CITY OF CARMEL-BY-THE-SEA
PLANNING COMMISSION
AGENDA CHECKLIST

MEETING DATE: 1 May 2013

STAFF REPORT

SUBJECT: CONSIDERATION OF RECOMMENDATIONS TO THE CITY COUNCIL
REGARDING AN ORDINANCE AMENDING MUNICIPAL CODE
SECTIONS 12.28.180, 12.28.350 AND 17.48.080 TO REVISE THE TREE
REMOVAL PERMIT REQUIREMENTS.

A3.1

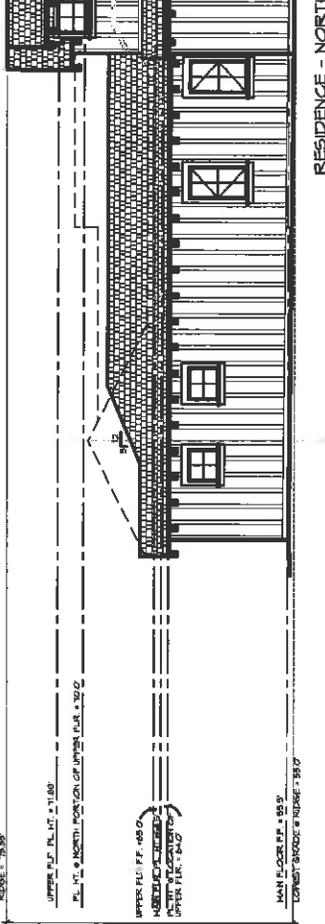
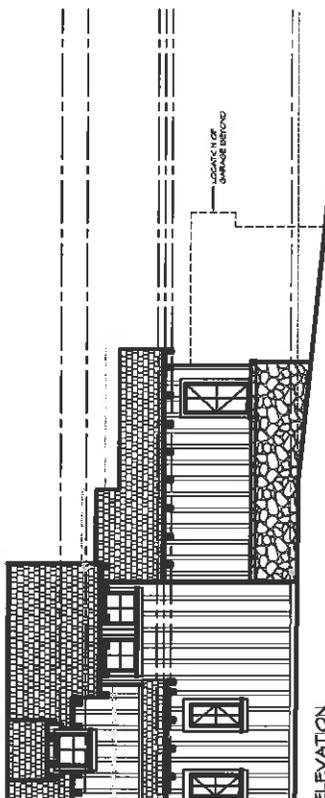
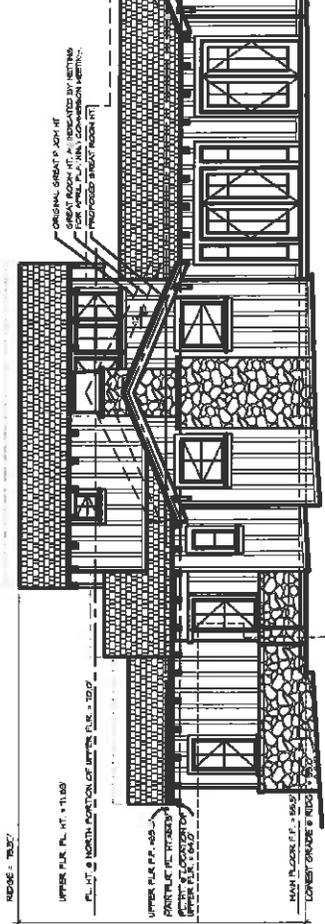
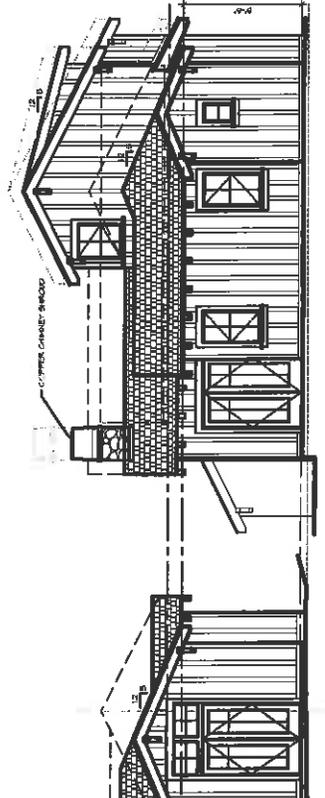
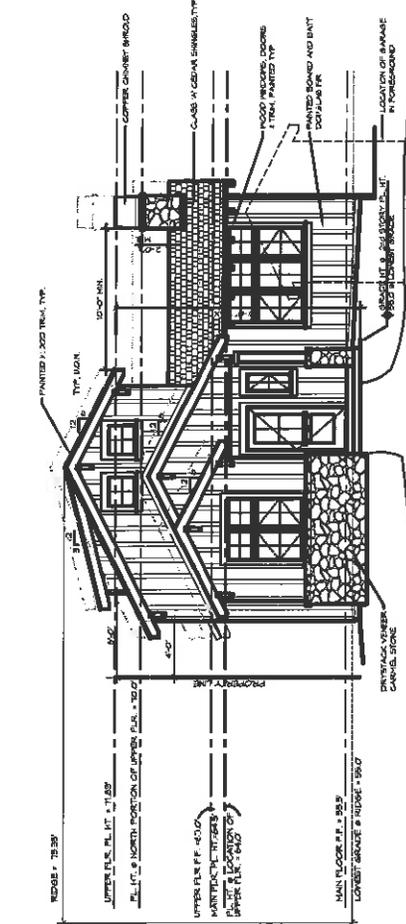
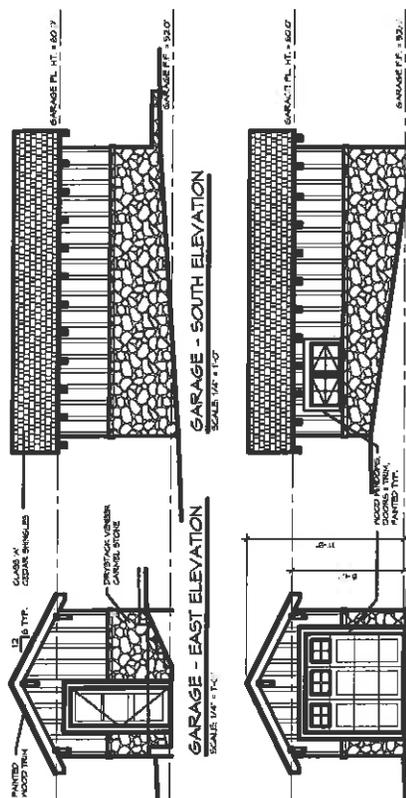
View Impact: The great room originally had a height of 16 feet. However, between the first and second meetings the applicant dropped the height of the great room by 26 inches. At the last meeting the Planning Commission determined that the Great Room needed to be lowered and additional one foot. This recommendation was primarily based on the use of the story-poles to evaluate the view impact.

Since the last meeting the applicant has evaluated the story-poles and determined that the ridge line was set seven inches too high (see attached letter). The applicant is proposing to lower the height an additional six inches. As a result the story-poles will be lowered 13 inches from what was seen at the last hearing. The Commission will have another opportunity to view the revised story-poles on the tour. If there are still concerns about the view impact the approval could be conditioned so that the height of the great room is further reduced, possibly another six inches.

For the second meeting (April PC) we dropped the overall floor height to 55.5', dropped the plate to 9'-0" and went to a 5:12 pitch, which should have resulted in an overall ridge height of 13'-1" above finish floor (ridge datum 68.65'). This is a drop of 26". Unfortunately due to a confusing drawing the storypole contractor set the orange netting for this ridge at datum 69.2', or 7" too tall (we showed a flashing strip against the second story element beyond which, due to poor line weight rendering, he assumed was the ridge in the gable view). During the meeting, and looking at the photo neighboring I thought the netting looked too high, and it was.

Please note that we also revised a bit the layout of the Master bedroom at the rear of the property. We dropped the plate of this entire wing by an additional 6" and shifted the edge of the bedroom wall 2'-2" further from the rear property line. We projected a gable approximately 2'-10" towards the south property line. The modest gable associated with this change is 8" below the Great Room ridge height and should not affect the eastern neighbor's view.

PROPOSED SITE PLAN
VAIS RESIDENCE
CARMEL REAL - 35W OF 11TH ST.
CARMEL, CA 93921
APN: 010.274.004

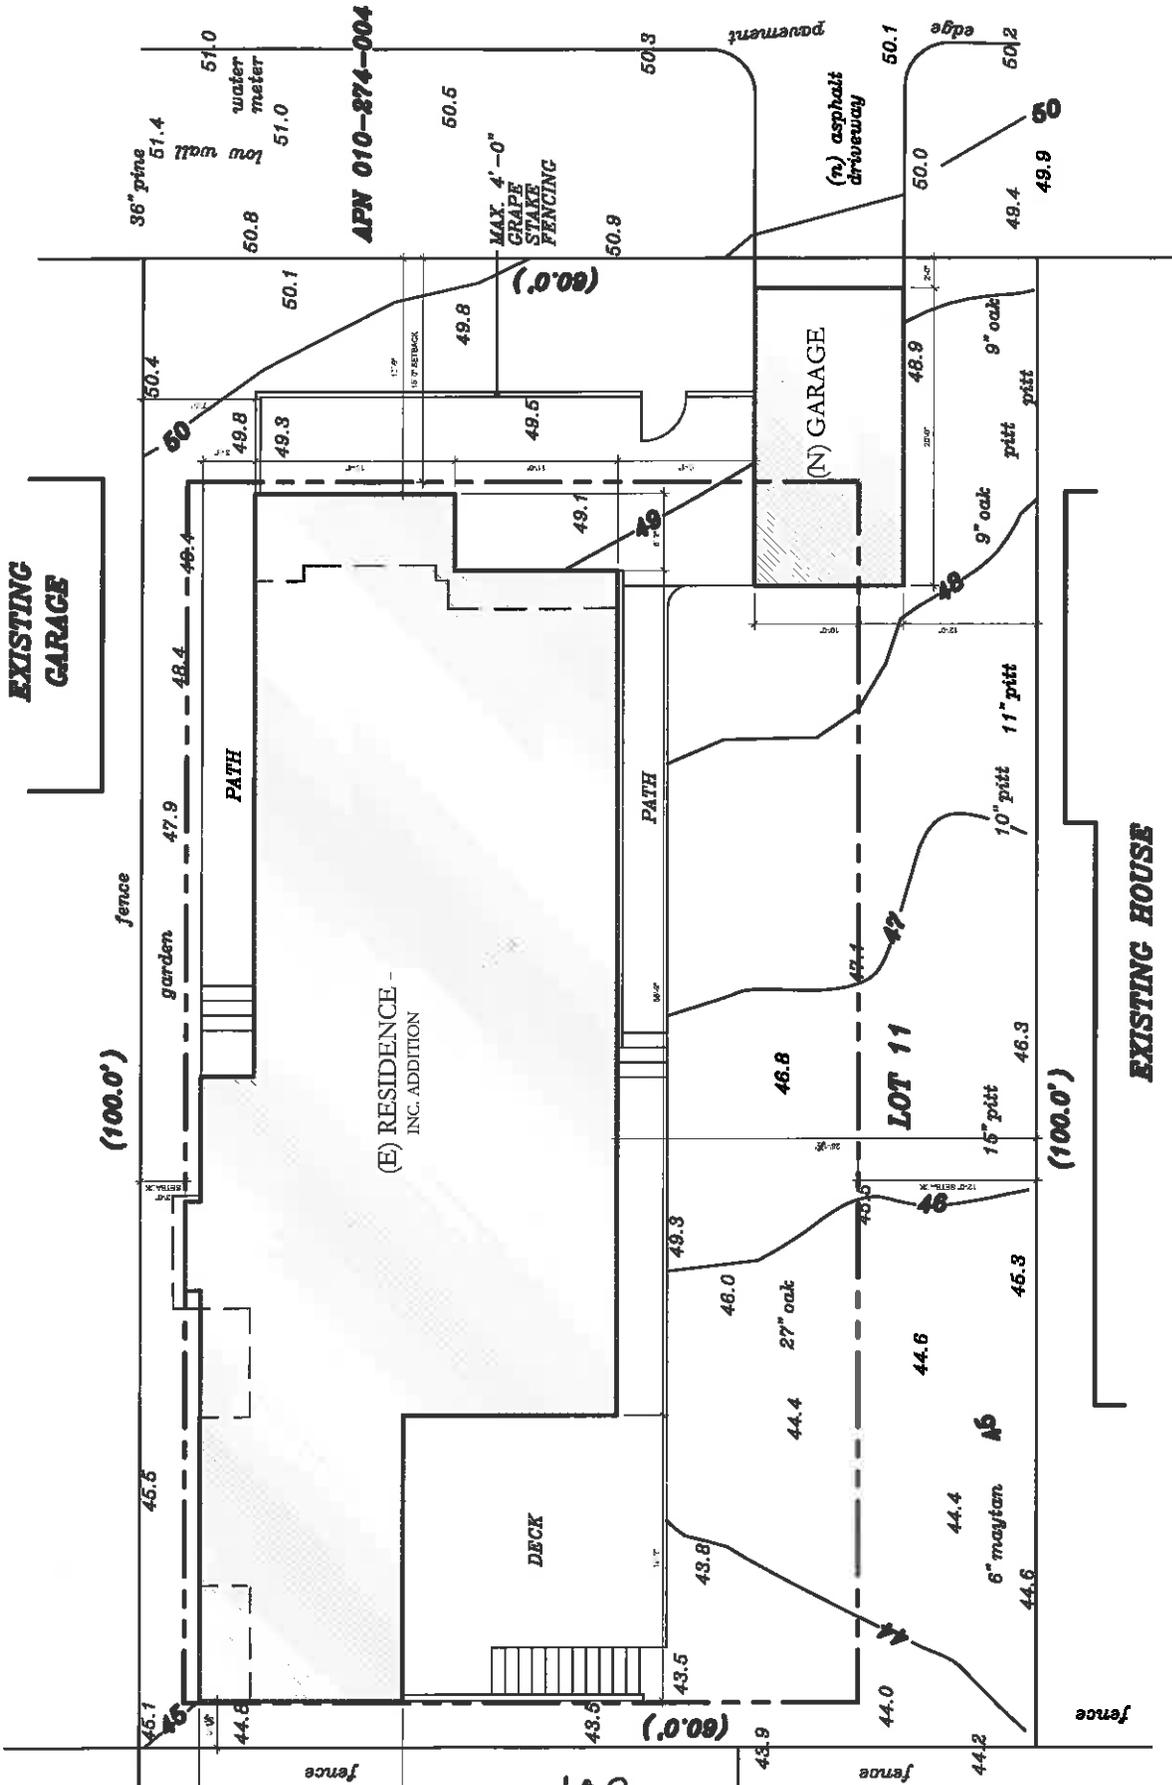
There is currently a driveway on the north side of the property that serves as an off-street parking pad. The parking pad is located in the front setback and is technically non-conforming. CMC 17.10.030.F requires properties to have conforming parking when adding floor area. In order to provide conforming parking the applicant is proposing to construct a garage at the southeast corner of the property two feet back from the front property line.

Staff supports covered parking on the site, but notes that the proposed garage and new driveway will disturb a nicely planted area in the right-of-way. A condition has been added that the applicant provide a landscape plan showing the elimination of the north driveway and replacement with new landscaping to offset the loss of landscaping on the north side of the property.

The applicant is proposing to locate the garage in the front setback primarily so that it does not impact their side-yard. The proposed garage is located two feet from the front property line. For this particular site the garage appears somewhat out of place at the proposed location. Staff recommends that the garage be set back an additional seven feet from the front property line to provide a greater setback from the street. A condition has been added to address this recommendation.

Landscape Plan/Site Coverage: The applicant is required to submit a detailed landscape plan with the working drawings to be reviewed by staff and the City Forester. As previously noted, the existing driveway shall be eliminated and replaced by landscaping as indicated on the site plan. A special condition has been added to address the landscaping requirements.

With regards to site coverage, staff has identified some inconsistencies on the data table. Staff did not have the opportunity to work with the applicant on this issue prior to the meeting. A special condition has been added that the applicant work with staff on the site coverage to ensure that it is properly documented and eliminated to the extent required by code.

Chimney: CMC 17.10.030.B states that the maximum allowed horizontal dimensions of a chimney are three feet and four inches. The proposed chimney is approximately six feet wide and eight feet at the base along the north elevation. A special condition has been added requiring the applicant to bring the chimney into compliance.

4. The applicant shall submit a detailed landscape plan including a proposal to eliminate the driveway and replace with landscaping on the property and in the public right of way.

5. The applicant shall work with staff to ensure that the site coverage is properly documented and is eliminated as required by code.
6. The applicant shall revise the chimney so that it does not exceed three feet and four inches in any horizontal direction.

EXISTING FLOOR PLAN
 VAIS RESIDENCE
 CAMINO REAL - 35W OF 11TH ST.
 CARMEL, CA 93921
 APN: 010274004

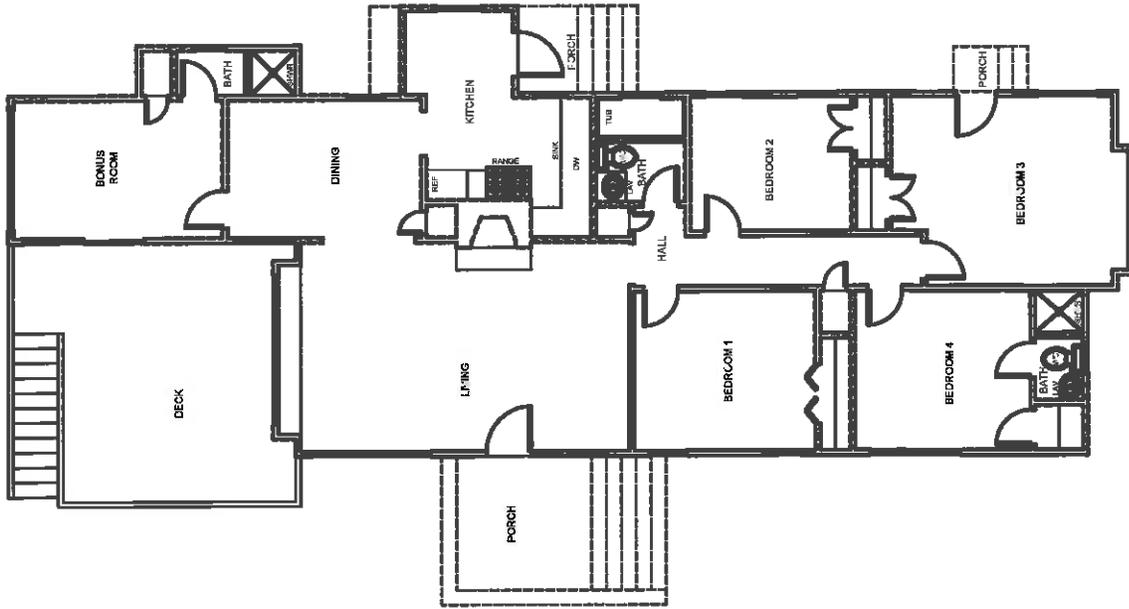
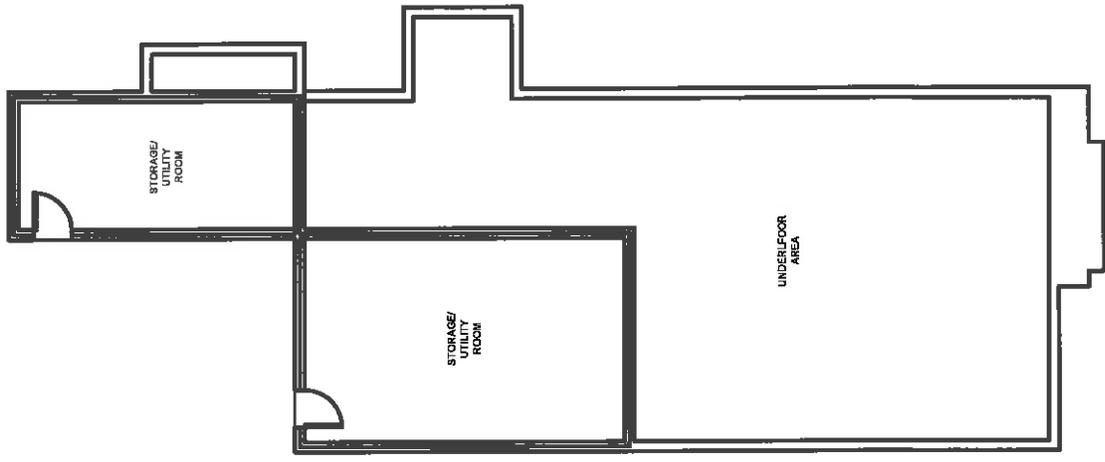
The proposed project minimally increases the size of the residence. However, the northern neighbor has expressed concern with the proposed kitchen additions on the north elevation. The additions create a continuous wall with a four foot setback from the north property line. The wall plane of the existing residence is staggered with portions having a seven foot setback. However, the neighbor's primary concerns appear to be more related to the privacy impacts from the windows and less with the massing.

Last week we received the Public Notice and we came to the Town offices and met with TJ to look at the Plans. The planned redevelopment and expansion of the north side of the neighboring house is of great concern for our privacy. The plan calls for the neighboring house to be built approximately three feet closer to our property with a increased plate height, while raising the roof line. Currently that portion of the neighboring house borders our small patio yard and is across from our sunroom/guest bedroom both of which are set lower than the neighboring structure. Currently one small obscure glass window exists along the referenced portion of the north facing wall of the neighboring house. The proposed plans call for 3 large windows to be built in the same span of the structure. This new structure will therefore loom higher and closer and create a "fish bowl" in what now is a very, small private patio and sunroom, that we enjoy daily. Because our patio area is south facing and shielded from the wind, we spend allot of time using the space. With the increased massing and these additional windows so close and directly over our patio, even a private conversation would be difficult.

We ask that the two most north-westerly windows be eliminated from The Plan, which leaves two windows remaining on that wall on either side of the proposed fireplace and of course all their west wall windows and banks of south facing windows. Our request would be in keeping with the way windows are placed on our house and the new house built to our north as well as the house on the south border of the proposed property redevelopment. This has historically respected and protected neighbors' privacy.

FLOOR PLAN
1/4" = 1'-0"

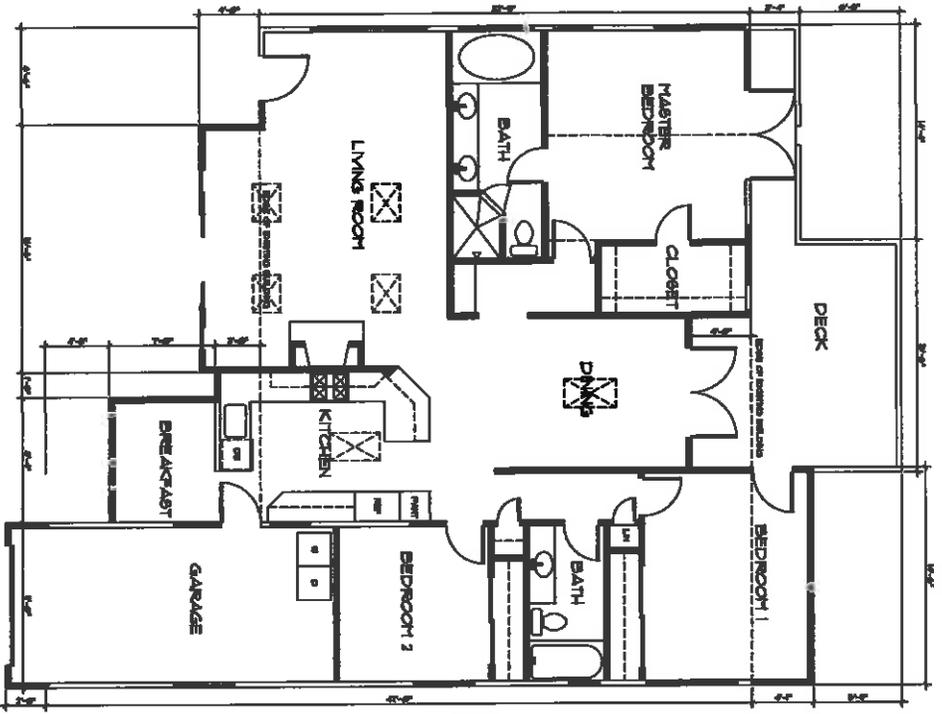
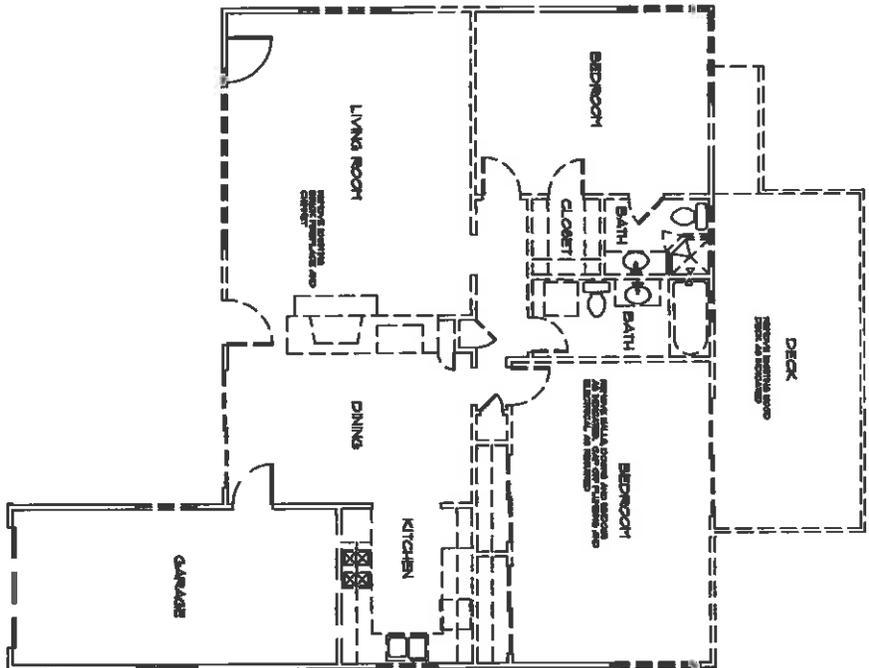
Past Planning Commissions have allowed the elimination floor area contained within the crawl space by lowering the ceiling height if it could be determined that entire residence would pass volumetric requirements. The concern was that the residence would still present the same exterior mass, even though the floor area is being eliminated. The issue with requiring a volume study of the entire residence is that often times the residence will not pass the volumetric requirements.

What makes this project unique is that floor area is being eliminated without any reduction to the exterior of the residence. It is understandable why past commissions have required the entire residence to pass volume. However, it is fairly clear that for this project the subject residence would not pass volumetric requirements. Staff is concerned with the hardship that it would create for the property owner by essentially reducing the habitable floor area by 202 square feet.

If the Commission supports this project then it could require that only the additions would have to meet volume. Staff would also condition the approval so that the applicant or future property owner would be restricted from improving or conditioning the crawl space for habitation at a future date. This project presents an opportunity for the Commission to discuss how the City should treat crawl spaces. This discussion will have implications for other future projects.

Design: Staff has not identified any significant issues with the proposed remodel, other than the issue of floor area as discussed above. The proposed additions meet the setback and height requirements and the building forms are consistent with the design of the existing residence.

The Commission can provide feedback to the applicant on the finish materials. For example, the applicant is proposing to convert the residence from wood to stucco which should be discussed. Design Guideline 9.5 states that *"stucco, in conjunction with some natural materials, may be considered depending on neighborhood character but should not be repeated to excess within a block."*
